ADDENDUM NUMBER: TWO [2]

PROJECT: Provalus Whiteville

ARCHITECT'S PROJECT NO: 24002

DATE: November 27, 2024

DEMOLITION - FIRST FLOOR PLAN

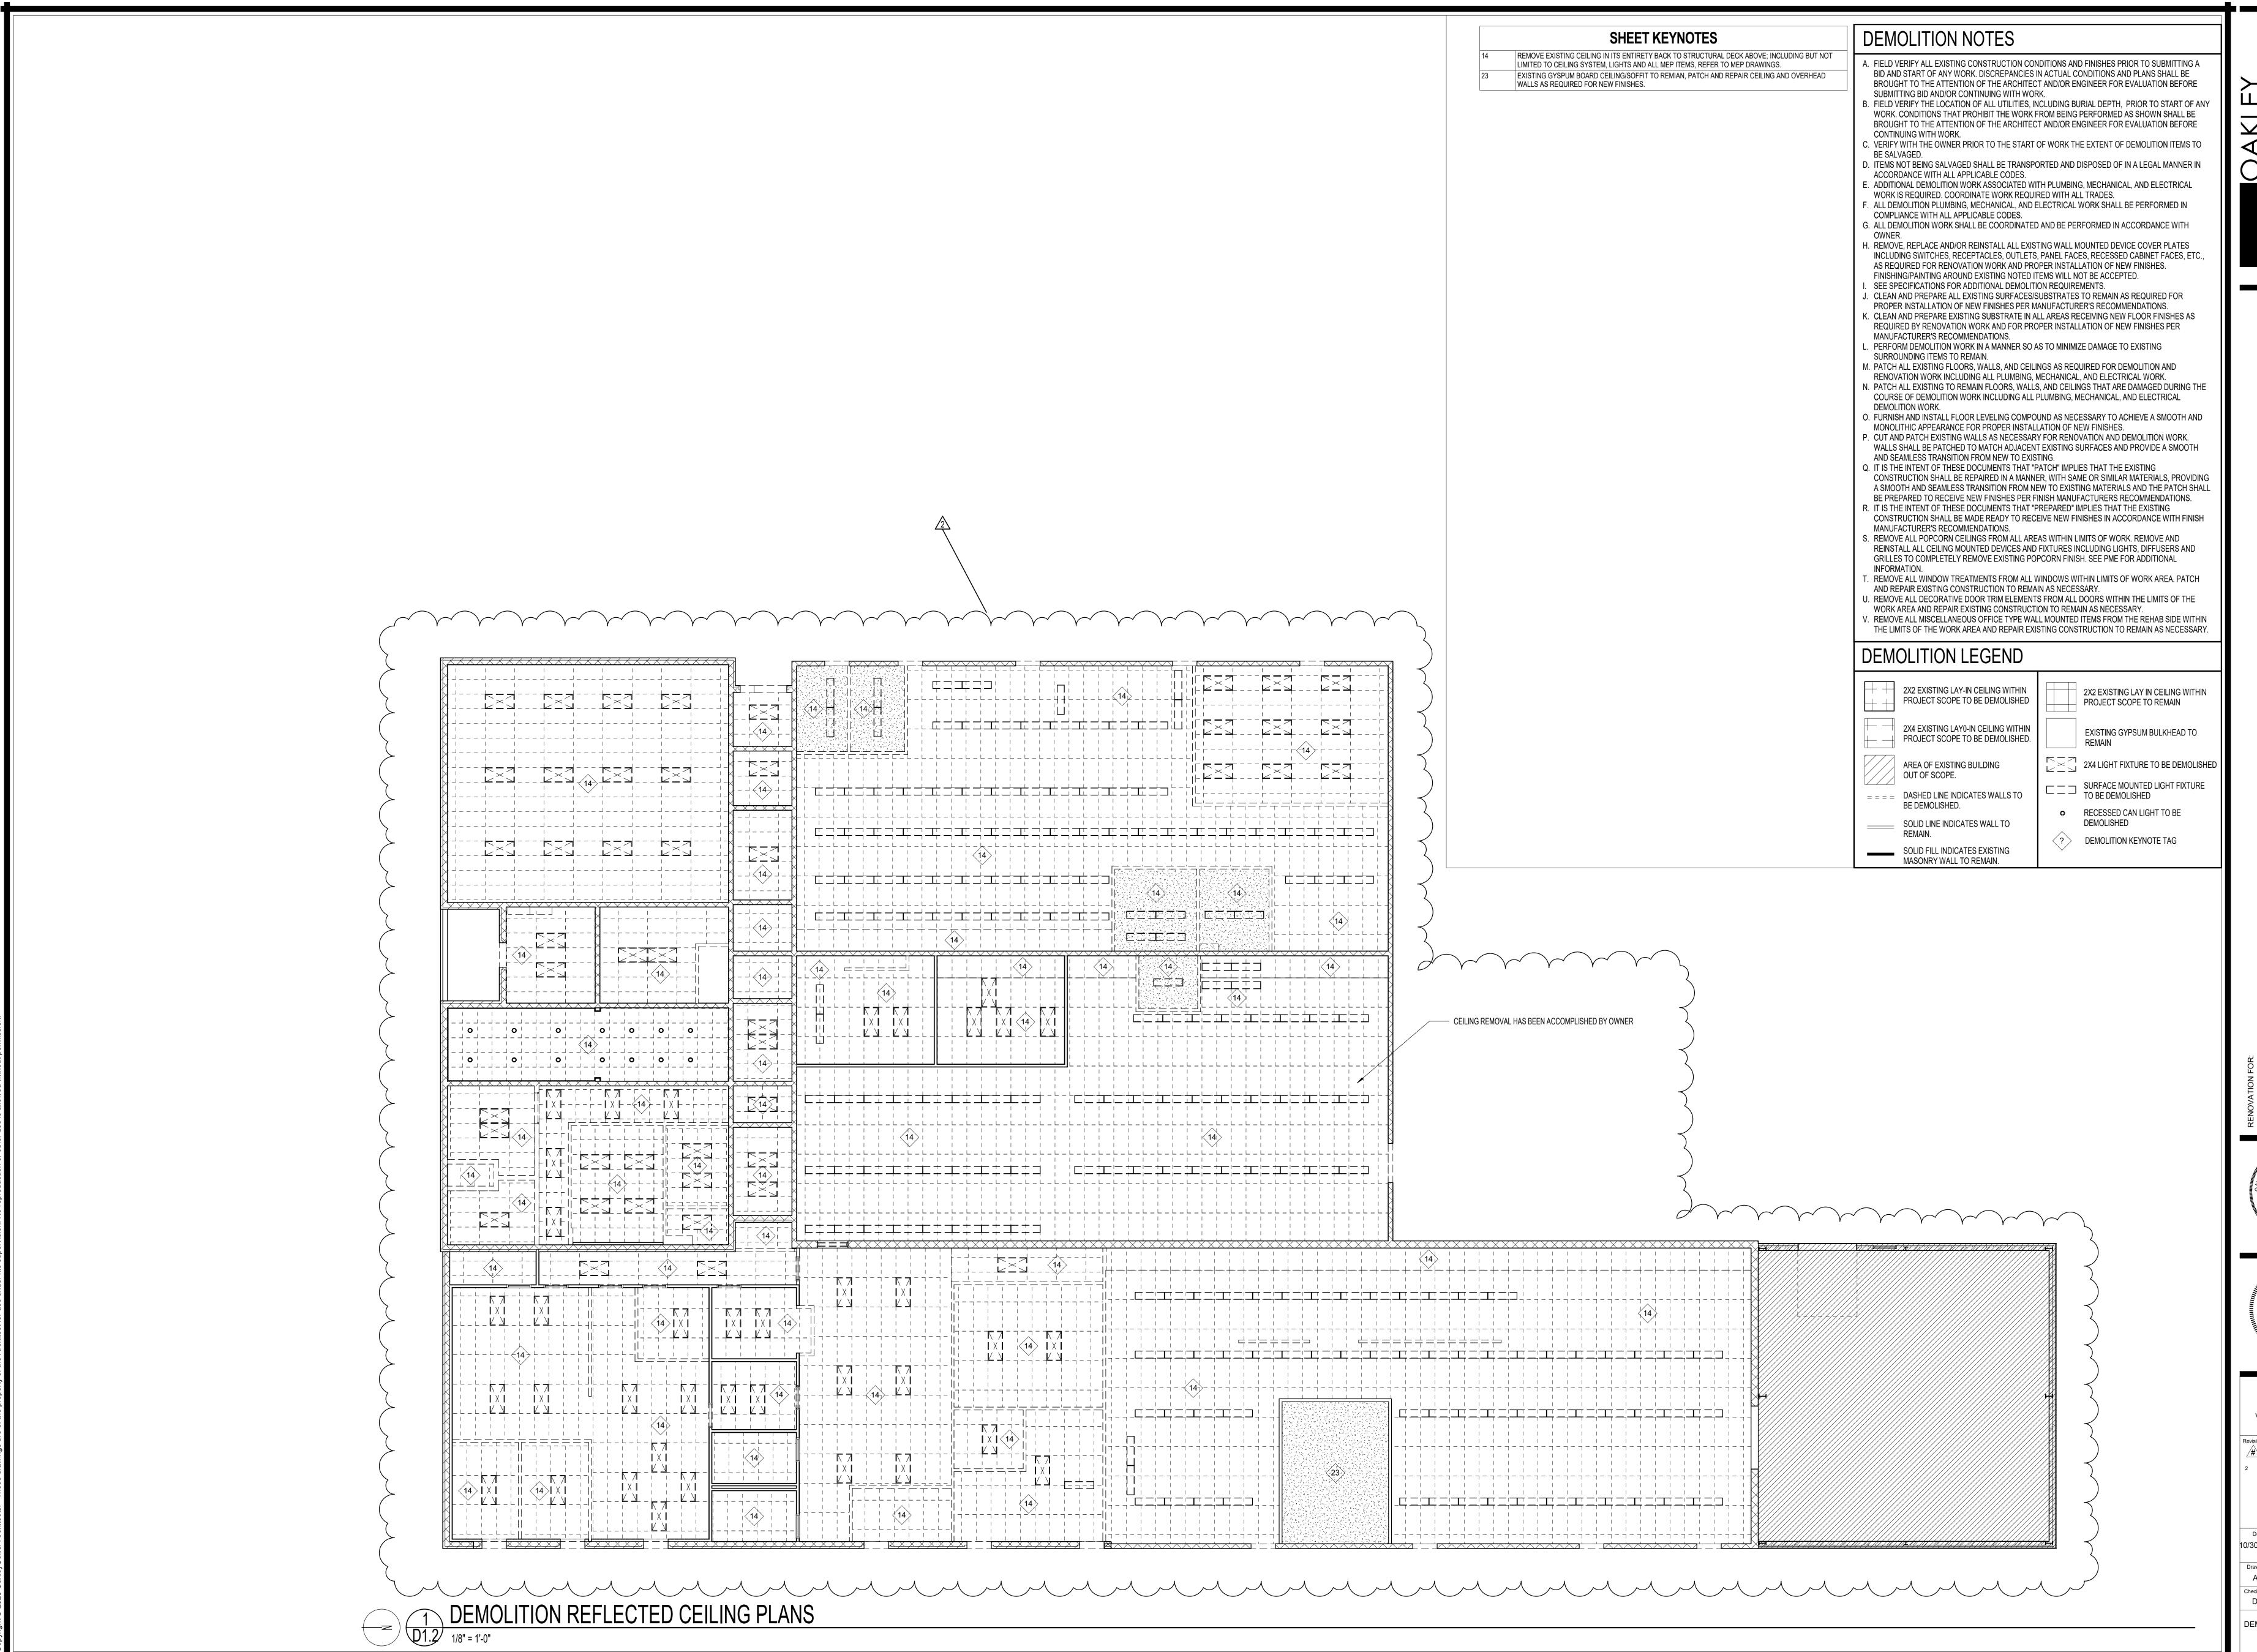
Item 8 Revision Sheet D1.1 – Demolition – First Floor Plan

Updated to remove demolition already completed by owner.

- 2. Existing floor trench to remain and openings to be filled in and leveled using Allowance 4 Concrete Leveling
- 3. D1.1 has been updated to removed demolition that has already been accomplished by owner.

Sheet Title
DEMOLITION - REFLECTED
CEILING PLAN

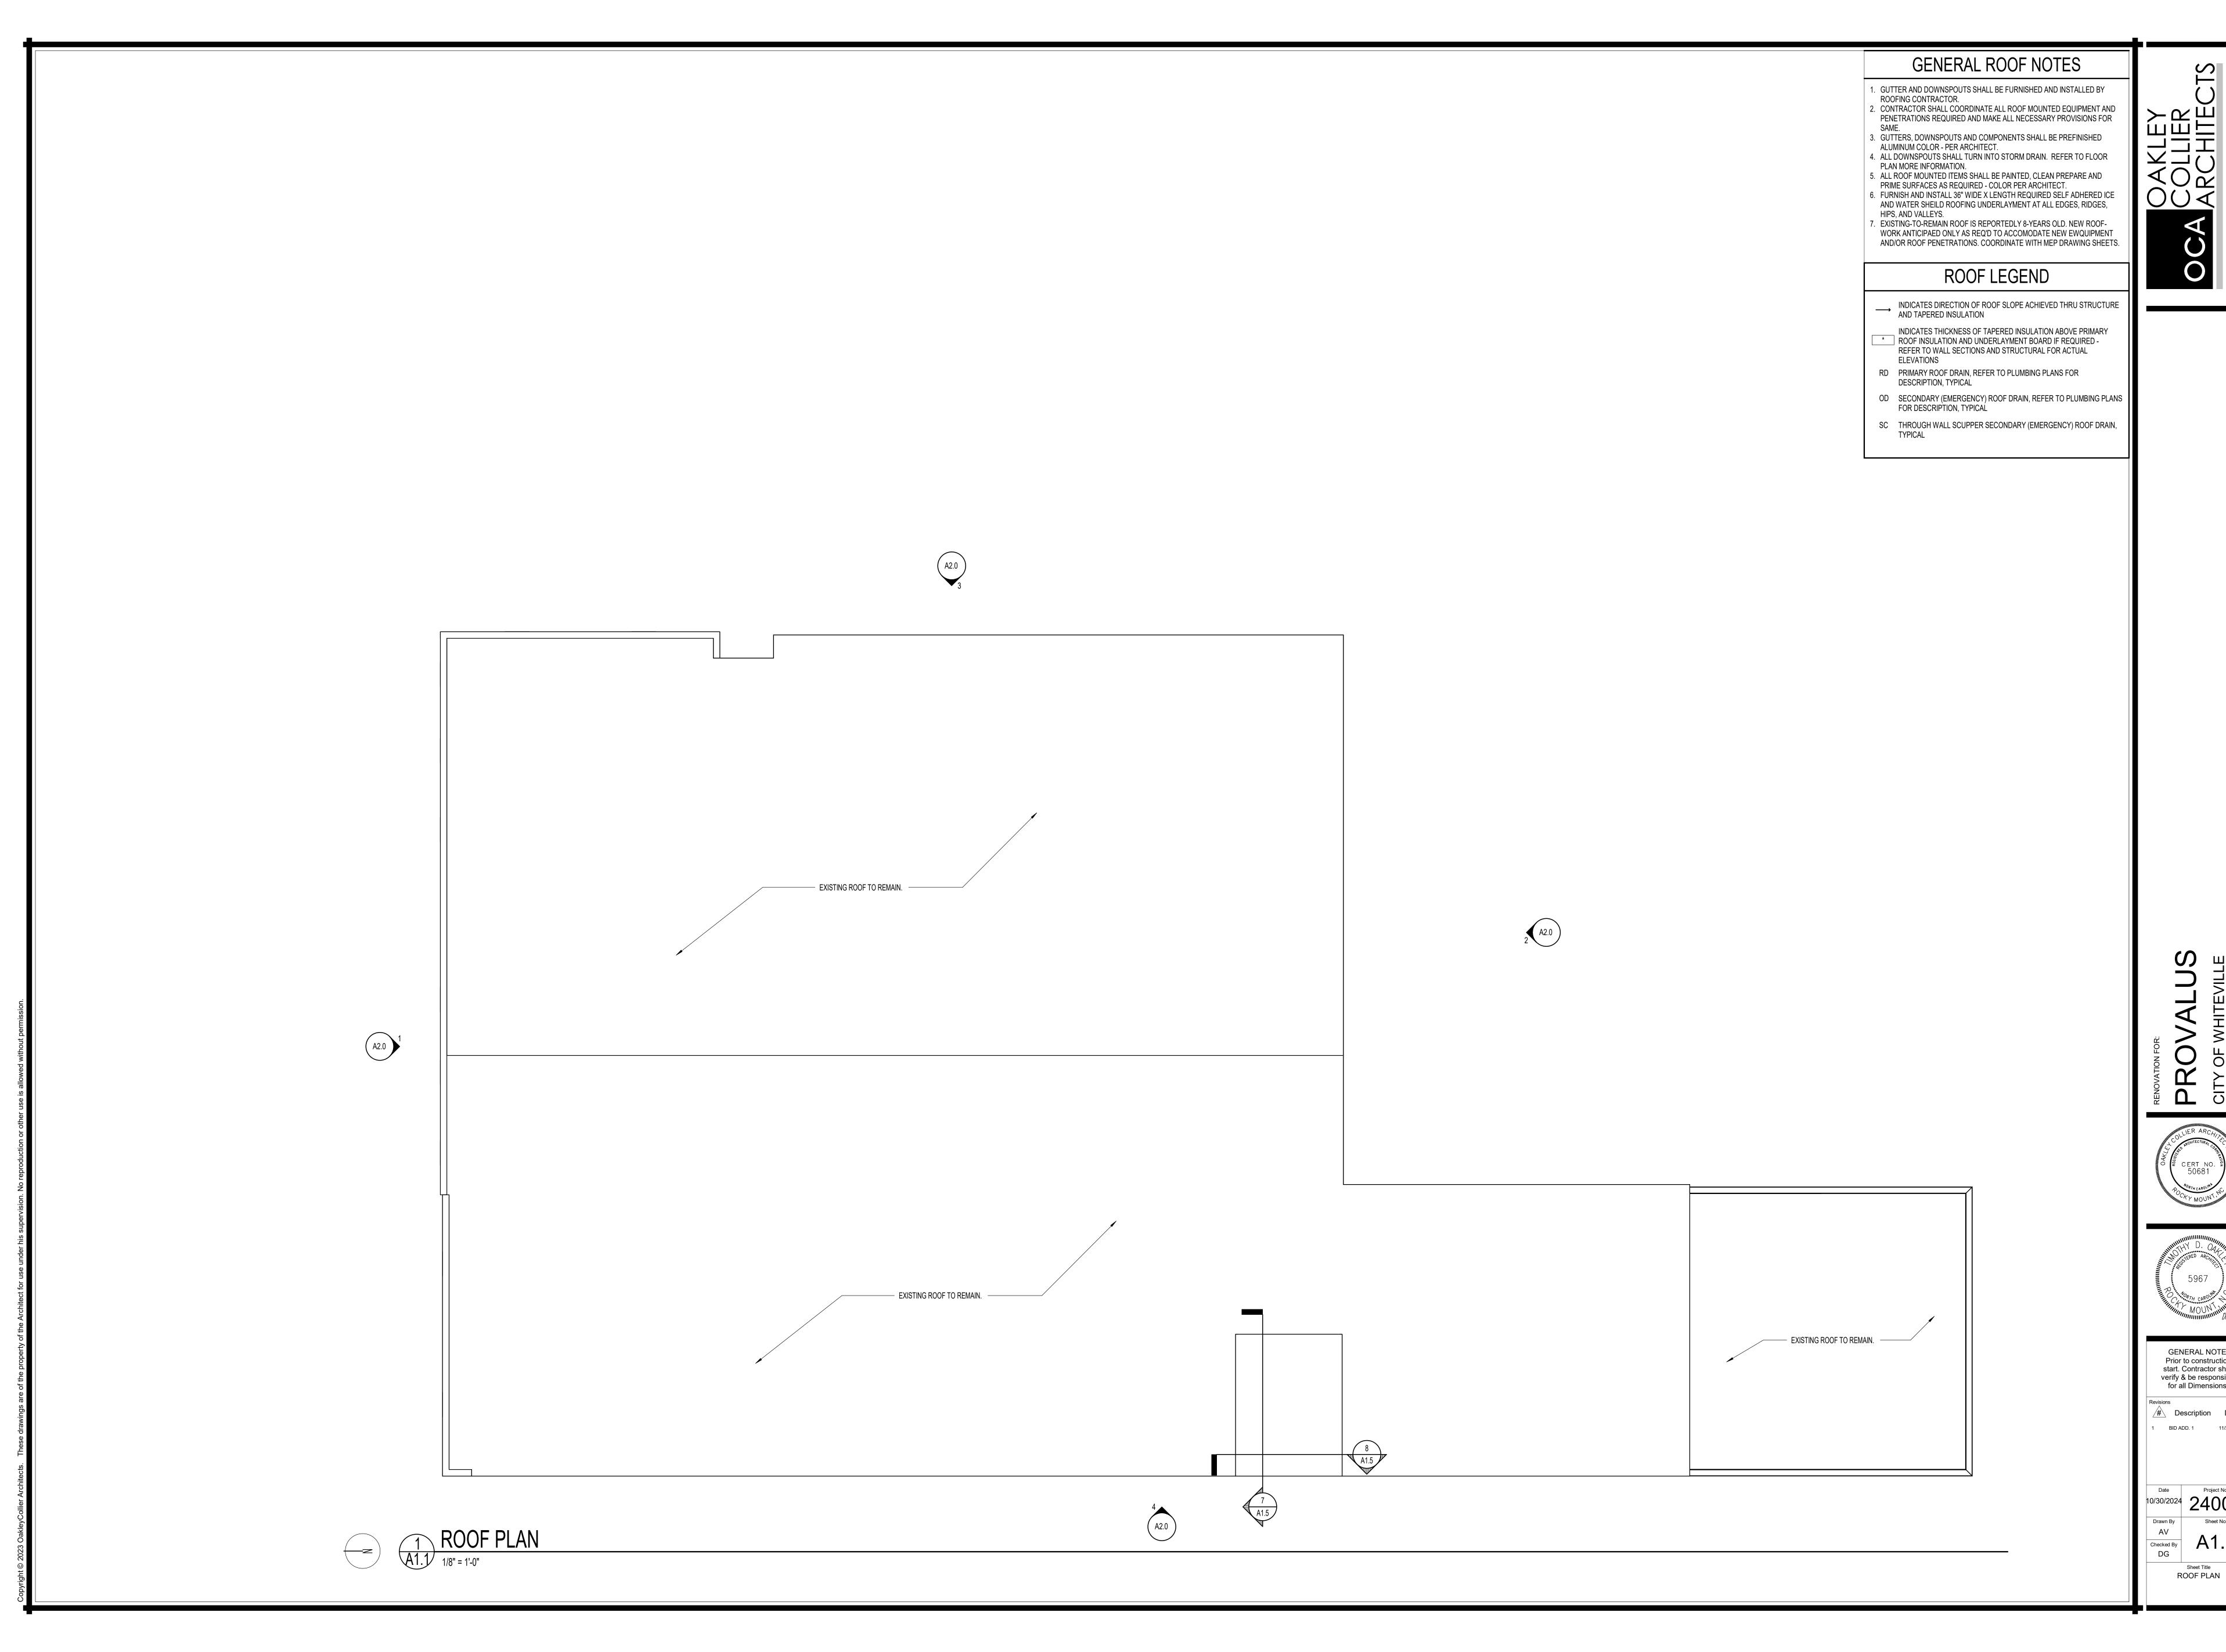
Item 9 Revision Sheet D1.2 – Demolition – Reflected Ceiling Plan

Updated to remove demolition already completed by owner.

- 4. Ceiling demolition has been accomplished by owner. Clouded and shown on D1.2.
- 5. Shower insert added to TA Schedule. Use Bradley 3x3 insert or other approved substitution.
